# BSA SERVICE SHEET No. 415A

July, 1955  
Revised Nov. 1957

Fig. 1: 'C' GROUP MODELS VALVE TIMING CHART

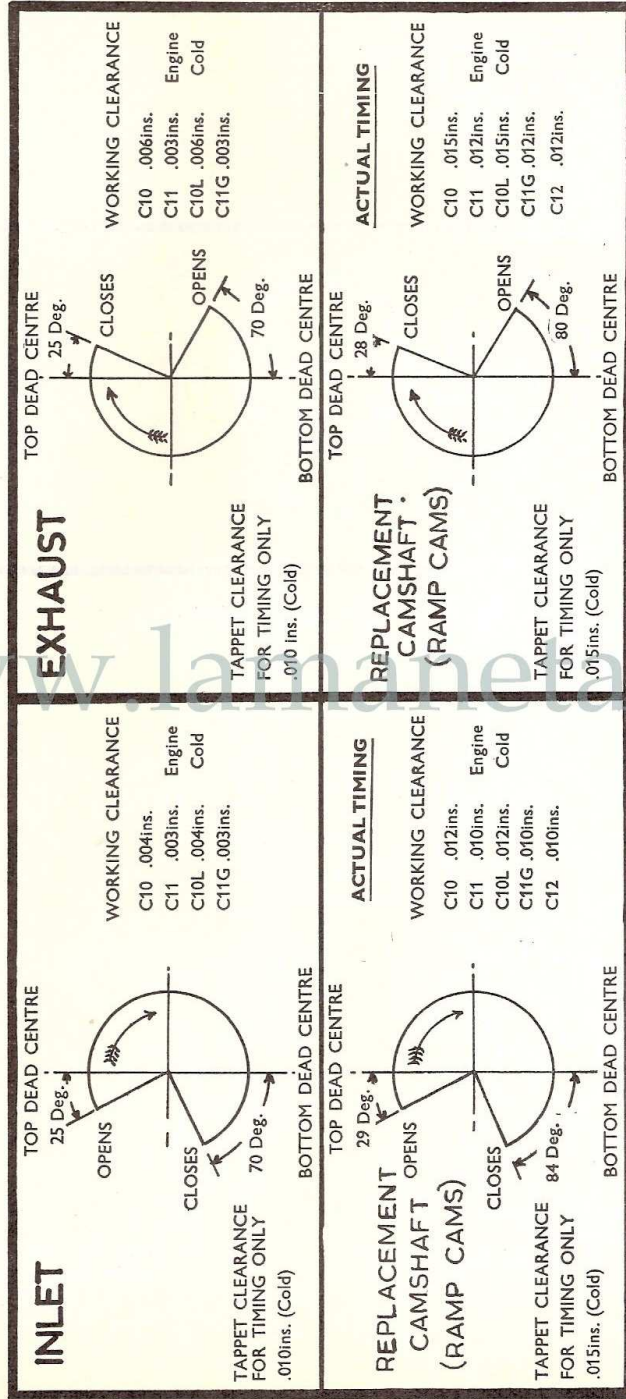
NOTE: Ramp type camshafts bear the following part numbers:-  
C.10—29-2078; C.11—29-2075; C.10L—29-2075; C.11G—29-2076, and can be used to replace the original camshafts in early models.

They are fitted as standard on and after Engine numbers:-  
BC.10L—3562 and BC.11G—10438.

When ramp cams are fitted, the inlet valve clearance must be checked or adjusted when the exhaust valve is about to open. The exhaust valve clearance must be checked or adjusted when the inlet valve has just closed.
